Hood Opening  
Angle Insufficient  
CXU

## FSB 820-001, Hood Opening Angle Insufficient

(November 2012)

W8078009

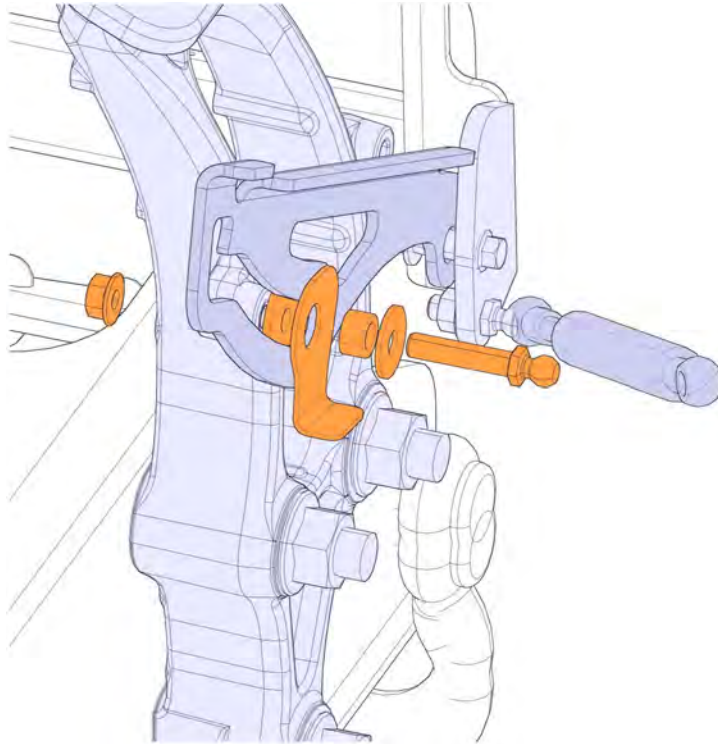
- 1 Secure the vehicle for service by parking it on a flat level surface, applying the parking brake, chocking the rear wheel, and placing the transmission in neutral.
- 2 Disconnect all cables from the negative (ground) and positive battery terminals to prevent personal injury from electrical shock and prevent damage to electrical components.
- 3 Open the hood.
- 4 Remove the driver's side hood strut from the connector on the radiator support.
- 5 Remove the driver's side connector from the radiator support.
- 6 Install the replacement mounting bracket (part number 82723420) to the radiator support. Torque the fasteners to 48 +/- 8 Nm (35 +/- 6 ft-lb).

- 1 – Bracket, Part Number 82723420
- 2 – Bolt, Part Number 990862
- 3 – Nut, Part Number 990941
- 4 – Connector, Part Number 21009167
- 5 – Existing Nut

- 7 Install the replacement connector (part number 21009167) onto the mounting bracket. Torque the fasteners to 48 +/- 8 Nm (35 +/- 6 ft-lb).

**Note:** Reuse the nut from the original installation. Reference number 5 of the illustration in Step 6.

W8076409

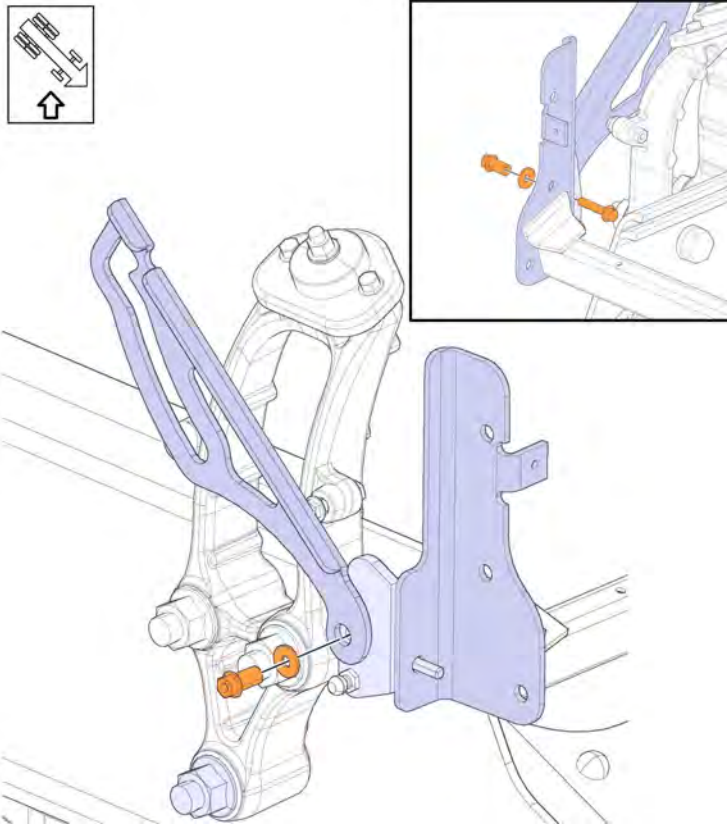
- 8 Install the hood strut onto the connector.
- 9 Remove the passenger side hood strut from the connector on the radiator support.

W8078039

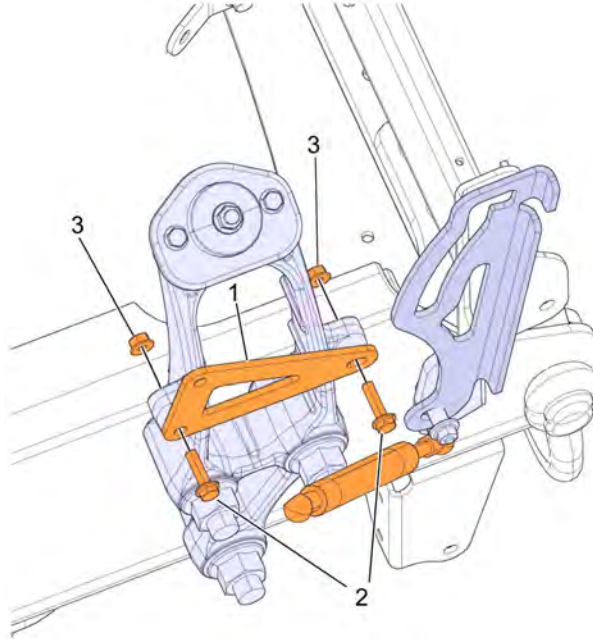
- 11 Turn the hood cross brace around to face the opposite direction and install. Torque the fastener to  $24 \pm 4$  Nm ( $18 \pm 3$  ft-lb).

W8078040

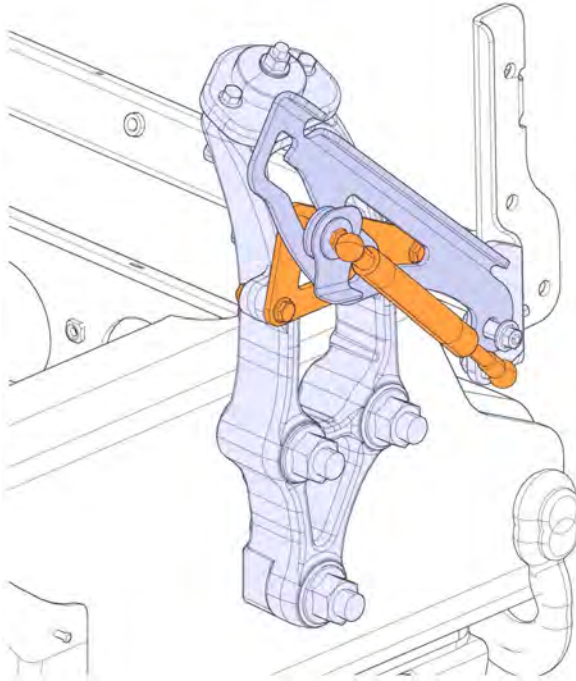
- 12 On the passenger side, install the replacement mounting bracket to the radiator support. Torque the fasteners to 48 +/- 8 Nm (35 +/- 6 ft-lb).

- 1 – Bracket, Part Number 82723420  
2 – Flange Screw, Part Number 990862  
3 – Flange Nut, Part Number 990941
- 13 Install the hood strut connector (part number 82058995) through the safety latch on the new mounting bracket. Torque the fasteners to 48 ± 8 Nm (36 ± 6 ft-lb).
- Note:** Reuse the nut from the original installation.

W8074960

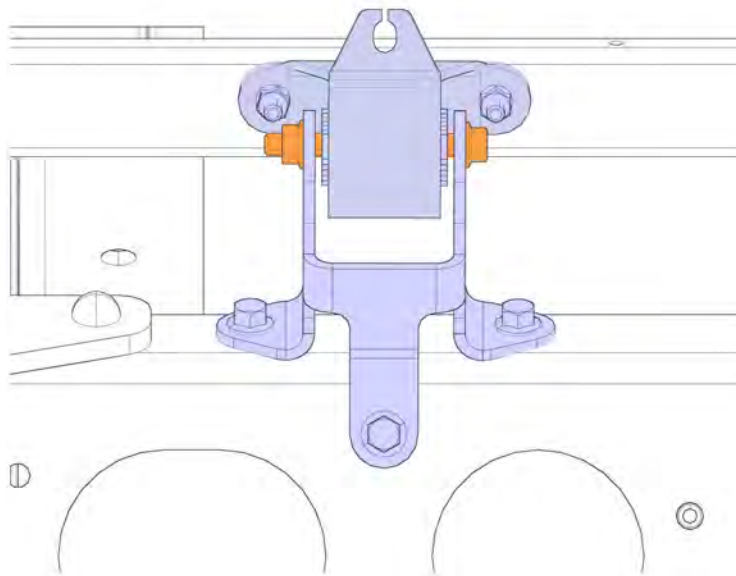
- 1 Inspect the hood for clearance issues between the grille and hood hinge.
- 2 Remove the grille.
- 3 Loosen the hood pivot supports bolts. Using a pry bar adjust the pivot to allow proper clearance.

- 4 Torque the fasteners to 48 +/- 4 Nm (35 +/- 3 ft-lb).
- 5 Recheck the hood gap after the adjustment. Readjust if needed. Once the hood is adjusted properly complete the remaining steps in the procedure. If the initial hood adjustment was not sufficient complete "Hood Adjustment (Using Spacers)", page 8 .
- 6 Install all previously removed cables to the ground (negative) battery terminals.

W8074958

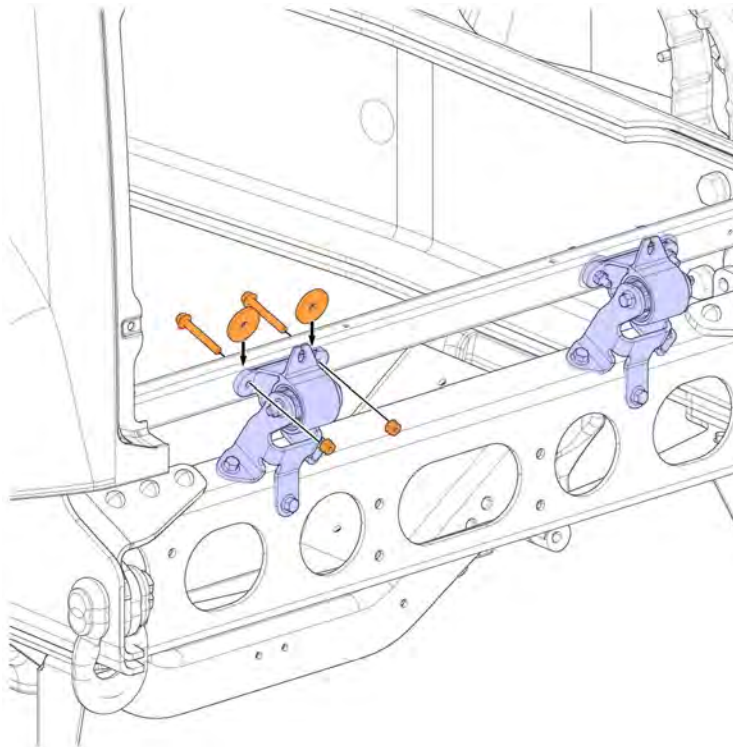
Remove one fastener at a time and add the spacer onto the hood pivot fastener.

- 5 After adding the spacer, loosely install each fastener.
- 6 Torque the fasteners to 29 +/- 1 Nm (21 +/- 1 ft-lb).
- 7 If additional adjustment is required, adjust per "Hood Adjustment (Without Spacers)", page 7 .
